June 23, 2015
Belfield Oil PHMSA Inspection Response

Reference: CPF 3-2015-5004 – Response to Proposed Compliance Order

Tank Layout

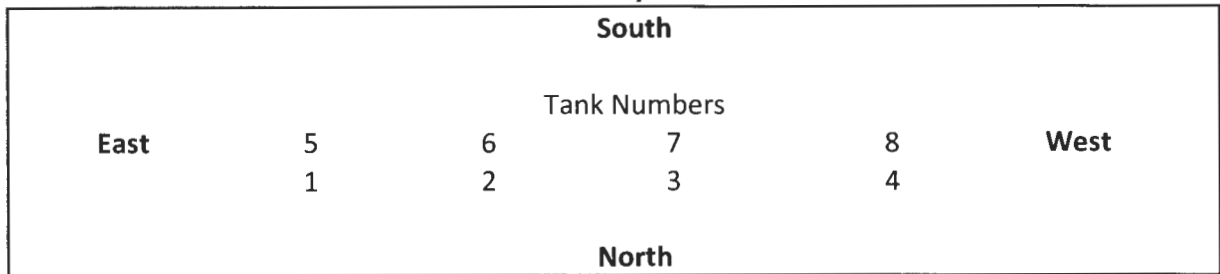
Whiting did not apply cathodic protection to the breakout tanks located in Skunk Hill station. Whiting thought that the tanks did not require cathodic protection because the tanks were under 500 barrels, per 195.565. However, 195.565 addressed the use of API 651 for installation of cathodic protection. It does not state that tanks under 500 barrels do not require cathodic protection. Another regulation, 195.563(a), requires pipelines to have cathodic protection within one year. Breakout tanks are part of the pipeline system per the definition on 195.2.

On Monday, June 8, 2015, the cathodic protection work on the 8 breakout tanks at the Skunk Hill tank battery commenced by CP Masters Inc. In total, 40 anodes were installed, five under each of the eight tanks. The anodes were driven in between the secondary containment barrier and the bottom of the tanks at roughly 72 degree increments. Prior to the attachment of the anodes a native survey of the tanks was

completed. In sum, 32 potential measurements were taken, four on each tank at the cardinal directions. The anodes were then attached directly to the tank by means of "pin Brazing". Once the anodes were attached a second "on potential" survey was conducted at the same test points to ensure the galvanic anode system was functioning as designed. Upon completion of the installation all excess material and waste was removed and the gravel around the 8 breakout tanks was raked and returned to the state it was in when the project began. The project is now complete.
